Ref: 10530/3983

RE: PROPOSED MOSQUE – CROUDACE ROAD ELMORE VALE

This letter addresses points raised in relation to acoustics in the “minutes of the Hunter and Central Coast Joint Regional Planning Panel meeting held at Newcastle City Hall on Thursday, 05 May at 5.30pm” (JRPP).

Figure 1 – Receiver Locations

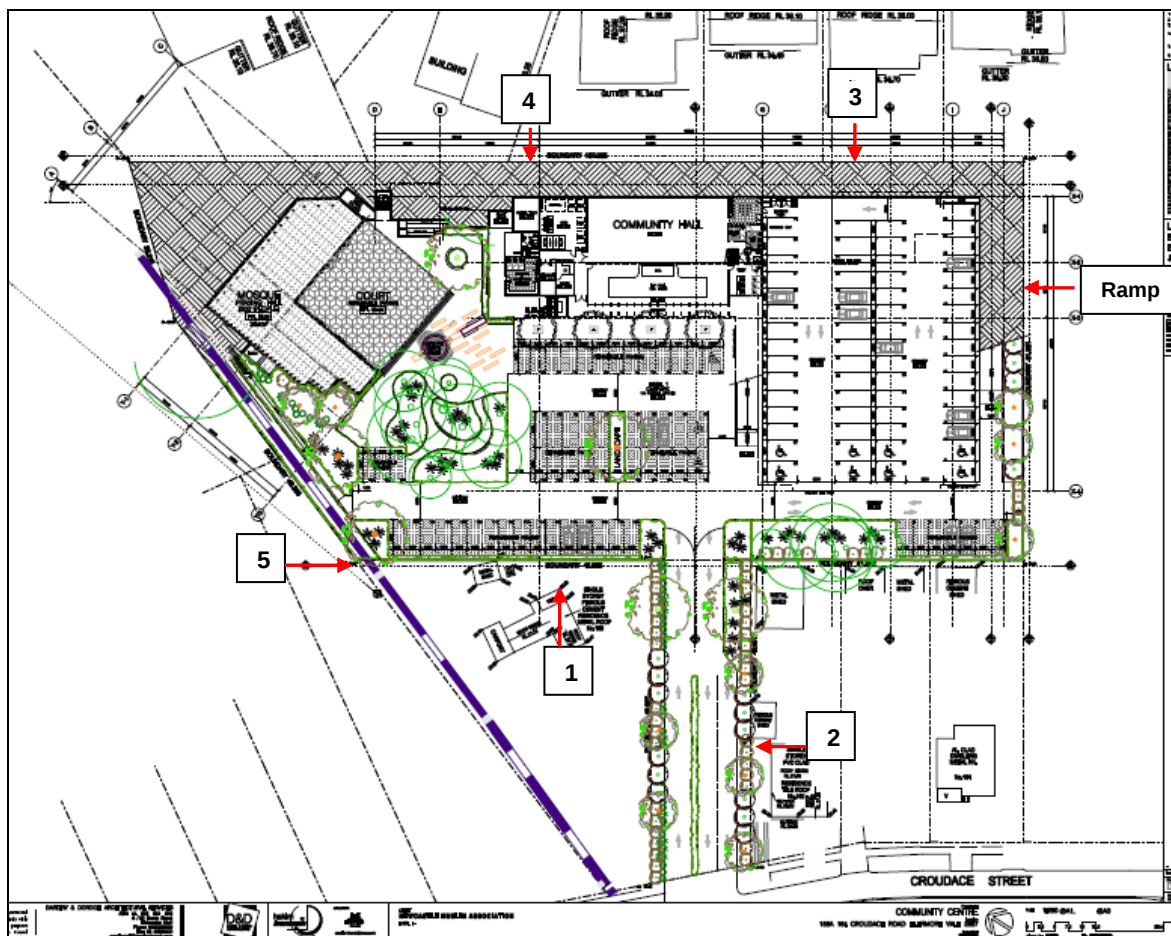
“The applicant to provide additional information in regarding noise impacts and issues in the independent acoustic consultant report by SLR including;

a) Addressing cumulative noise impacts, including under non-neutral weather conditions, and

“The Acoustic Report provides no assessment of the impact of noise sources occurring simultaneously under typical operational scenarios rather, individual noise sources from the proposed development are applied against the relevant criteria in isolation of other site noise sources. It is therefore, recommended that additional information be supplied regarding the cumulative noise contribution of the site under likely operational scenarios.”

The proposed operation of the mosque is such that there may be occasions when more than one noise source is occurring simultaneously. As indicated in the SLR report the worst case for noise generation will occur before and after the Friday Jumaa Prayer. During this time people will be arriving at the car park and moving into the mosque. The noise may therefore be from the driveway,

car park, courtyard at the mosque and mechanical plant. There will be use of the hall, other than for quiet individual prayers and readings. The noise from all of these sources has been determined (using all sound levels and assumptions from the original assessment by Spectrum Acoustics) at each of the five representative residential receiver points shown in **Figure 1**. To look at an absolute worst case the noise from the prayers session in the mosque has also been considered to be operating at the same time as the other noises detailed above.

Similar calculations to those shown above were carried out for the other receivers shown in Figure 1. The results of the calculations are shown below in **Table 6**.

Similar calculations to those shown above, for evening, were carried out for the other receivers shown in Figure 1. The results of the calculations are shown below in **Table 11**.

Figure 2 – Site Cross Section

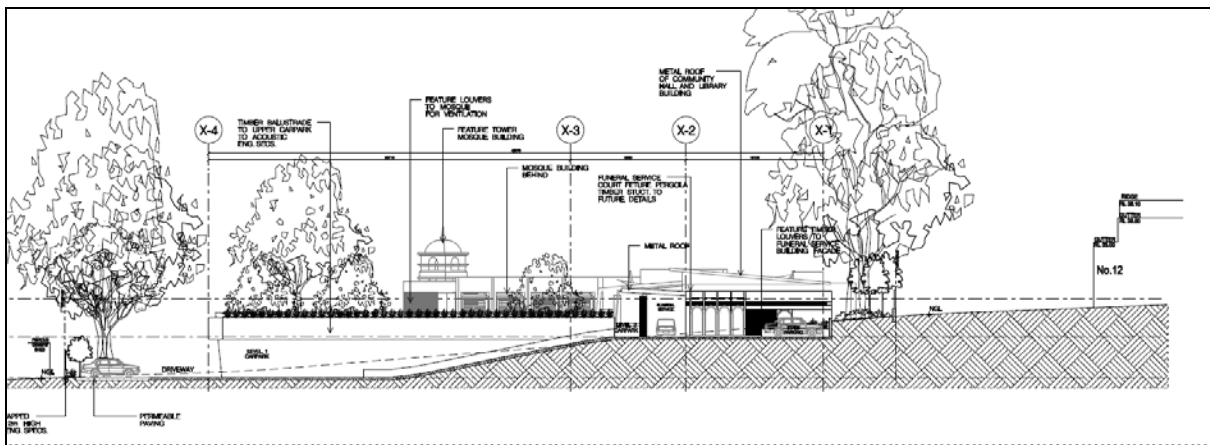
b) Noise impacts from the eastern ramp to the upper level car park.”

b) The upper level car park will only be used during the day. It will be closed off at all other times. **Figure 2** shows a cross section through the site which shows that the eastern ramp to the upper level car park rises in cut from existing ground level to the proposed FFL of the car park.

There will be a 2.1m high acoustic barrier along the boundary of the site adjacent to the ramp. Where the ramp rises above natural ground level then there will be a 2.1m high acoustic barrier at the boundary of the nearest residence.

Table 12 shows a calculation of noise impacts during the day from cars using of the eastern ramp. The calculation has been made to the most potentially affected receiver location marked as ramp on Figure 1.

The results in Table 12 show that, under the assessed conditions there will be no exceedance of the day time noise criterion as a result of vehicles using eastern ramp to the upper level car park.
